FOSTER CITY LEVEE PROTECTION PLANNING AND IMPROVEMENTS PROJECT

Response to Comments Document

Capital Improvement Project No. 301-657
State Clearinghouse No. 2016012012

March 2017

FIGURE 2 EXISTING LEVEE ELEVATION DEFICIENCIES FOR WAVE RUNUP

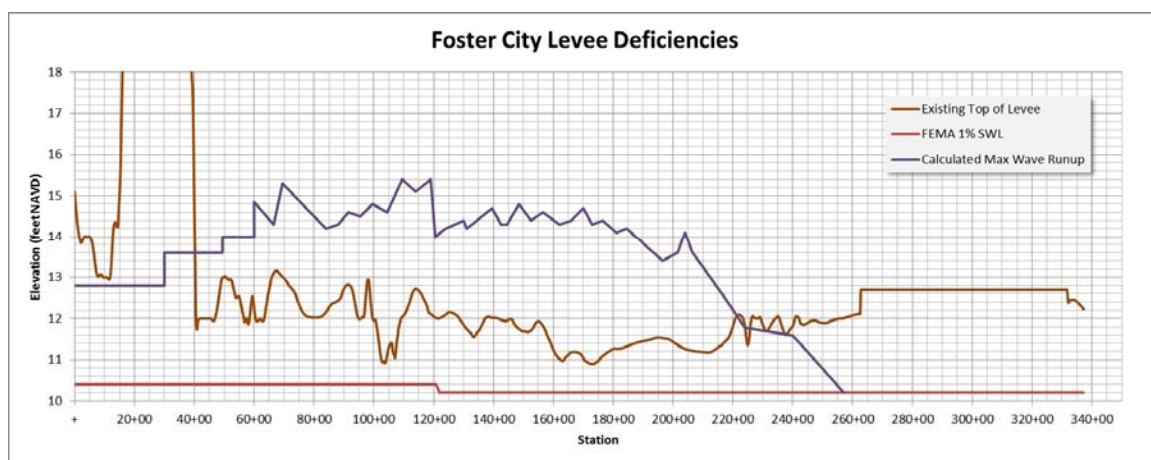
Response A1-2. The comment requests that the City develop a project alternative that maximizes the application of coarse shoreforms such as beaches, shell ridges, and similar features bayward of the existing shoreline, and revise the Draft EIR to reflect the analysis of this alternative.

There is a 2.5-mile stretch of the existing levee system that is subject to overtopping, spanning from the high ground at Mariner's Point on the west end to the shell bench on the east end near the mouth of Belmont Slough (Figure 2). This 2.5-mile stretch is broken into 10 sections, each with a similar average levee slope, and the break parameters and overtopping rates (in cubic feet per foot) are estimated for each section. Two methodologies have been chosen to estimate the mean rate of wave overtopping. The first, formulated by Owen (1980) and updated in the EurOtop overtopping manual, uses empirically derived coefficients for various structure slopes:

The 2.5-mile stretch of the existing levee system subject to wave overtopping is located between the high ground at Mariner's Point on the west end to the shell bench on the east end near the mouth of Belmont Slough (Figure 2 in response A1-2). This 2.5-mile stretch is broken into 10 sections, each with a similar average levee slope, and methodologies found in the literature are used to estimate overtopping rates (in cubic feet per foot) for each section and the volume of water spilling over the levees throughout the tide cycle is established based on the probability of wave overtopping for the given conditions.

FIGURE 5 OFFSHORE WIND EFFECT ON WAVE SETUP

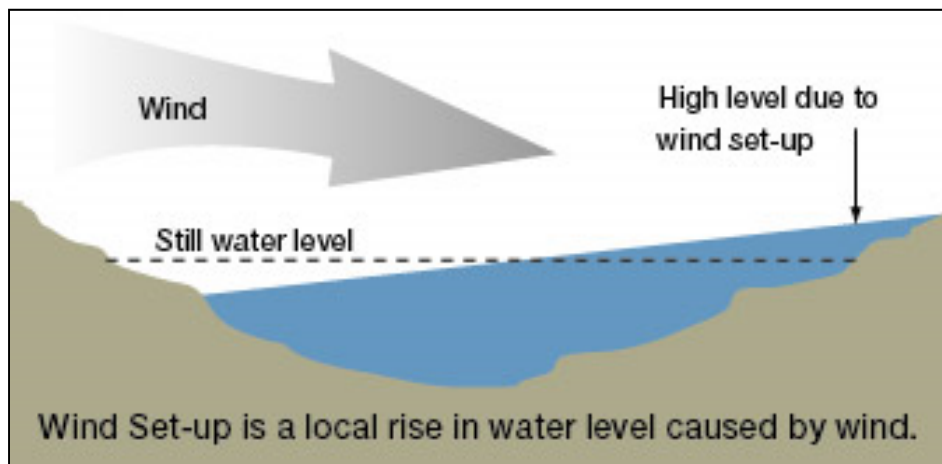
This comment also states that recent research by Professor Mark Stacey at UC Berkeley indicates that shoreline hardening in the South Bay may exacerbate tidal flooding elsewhere in the bay, often referred to as the “bathtub effect.” The project design team has been in contact with Dr. Stacey at UC Berkeley to discuss his research on the bay and its applicability to the project. Dr. Stacey clarified that he refers to “shoreline hardening” as preventing the bay from encroaching into an area currently subject to tidal flooding. He does not consider improvements to already hardened or armored shorelines, such as the Foster City levee, to be “shoreline hardening” because these shorelines are already protected against encroachment from tidal flooding. Because the existing Foster City levee does not experience overtopping during a 100-year tide event, Foster City is not currently subject to

It is also noted that prevailing winds would also act to render insignificant the impact of increasing freeboard at the Foster City levee system. Generally wave overtopping at Foster City would only occur when waves are directed towards the City's levees with a prevailing southwesterly wind. This condition would generally result in wind-induced setup, or a local rise in water surface downwind and an associated drop in water surface upwind; that is on the levee side of the bay, and in this case specifically, Alameda County. Conversely Alameda County should be more concerned about the impact of wind-driven waves when the prevailing wind is in the northeasterly direction, generally perpendicular to its shores; when at Foster City this prevailing wind is offshore and levee improvements to protect against wave runup are not in play. Figure 5 illustrates this effect.

As demonstrated above in Figure 5, the project would have only a negligible impact on water levels around the bay, far less than the 0.1-foot water level increase suggested by

FIGURE 8 "BAYSIDE LEVEE" RENDERING PREVIOUSLY PROVIDED BY LAW OFFICES OF MARK C. WATSON

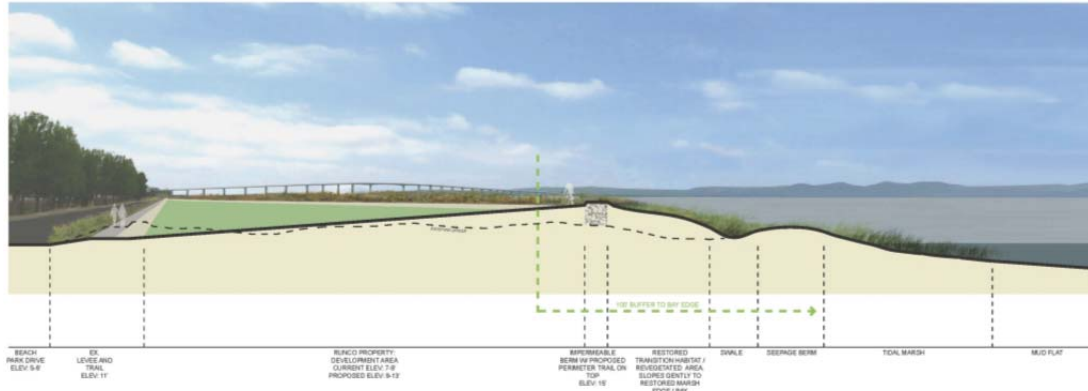
Response B1-9. The comment refers to mock-up renderings submitted by the Offices of Mark C. Watson, referred to as the "Bayside Levee" suggested by the commenter and included as Figure 8. These renderings appear similar to the levee realignment Mr. Runco

The alternative advocated by the commenter is not to be confused with a “horizontal levee” with hundreds of feet of offshore fill. A true horizontal levee that would effectively dissipate wave energy needs to typically be laid back with 30:1 side slopes as measured horizontal to vertical. Such a levee configuration could extend a significant distance into San Francisco Bay at the location shown on conceptual plans (shown in Figure 8) for this requested alternative. The alternative suggested by the commenter is rather a relatively traditional levee system, but with restored habitat on the offshore slope. Since an offshore breakwater is not shown, the levee elevation still needs to be sufficiently high to provide the requisite FEMA freeboard against wave overtopping.

The alignment of the “Impermeable Berm with Proposed Perimeter Trail” is not sufficiently precise to allow for a meaningful impact analysis. Figure 8 shows the location of the berm as apparently 100 feet away from the “bay edge,” with that edge defined as “tidal marsh,” but that edge is not defined in terms of tidal elevation. The requisite elevation of the “Bayside Levee” alignment would, therefore, need to be verified to determine its viability for wave protection since it is much closer to the shoreline than the existing levee alignment, which has been evaluated by the City in terms of required wave protection elevations.

Note however, that the City’s conclusion that the Bayside Levee alternative is not a feasible project alternative under CEQA, does not preclude the Bayside Levee alternative from being incorporated into or approved as part of Mr. Runco’s separate development project application which will require its own separate environmental review under CEQA and will have its own project objectives.

Figure 9. Model for 100-year Wave Overtopping of Existing Levees

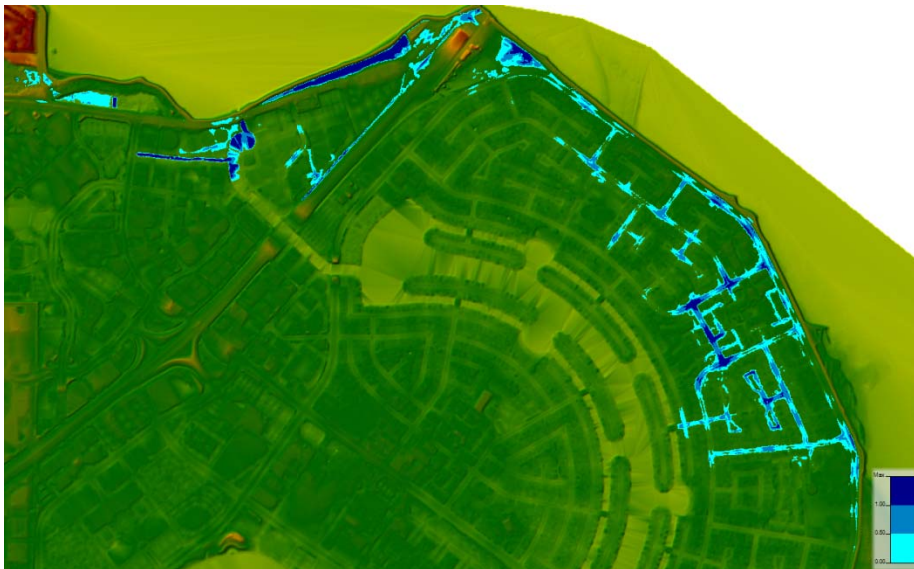
However, as noted on page 54 of the Draft EIR, Foster City (with the exception of the Central Lagoon) is currently located in Zone X with moderate-to-low risk of flooding from a 100-year flood. The comment is addressed below, relative to the existing condition. The profile in Figure 2 in response A1-2 shows the existing top of levee based on a detailed topographic

Figure 9 shows the results of a two-dimensional flow model that routes this volume of water from the perimeter levee system into the Central Lagoon; again, assuming that none of the levee system fails due to this overtopping. Although the levees are not designed with erosion protection for such overflow, it is noted that maximum overflow velocity is on the order of 2 to 3 feet per second, and while not acceptable for FEMA accreditation, it is relatively likely that the majority of the levee system would remain intact.

Figure 9 shows that bay waters are able to flow into the storm drain system and lagoon without excessively deep water spread over private properties. At its normal winter operating “storm level” of 1.0 foot NAVD, the surface area of the lagoon is 230 acres. The 23.3 acre-feet of water overtopping the levees would add about 1.0 foot of water to the lagoon. Without any pumping, the increase in water level would match the lagoon’s normal summer level of 2.0 foot NAVD. Thus the City’s existing facilities can accommodate the 100-year spill event under existing conditions, even without warning or prior evacuation of the lagoon; and there is no need to raise the pumping facility or equipment therein. Raising the levee as part of the project would greatly reduce the risk of wave overtopping and bay overflow into Foster City as shown in Figure 9, particularly since additional freeboard is provided relative to existing conditions. Since there would be no change to lagoon operations and the pumping facility is already protected against flooding, the pumps do not need to be raised in the future. Possible future sea level rise could result in higher levels in the bay that must be pumped against, but this can be adapted to by increasing individual pump horsepower within the existing facility.
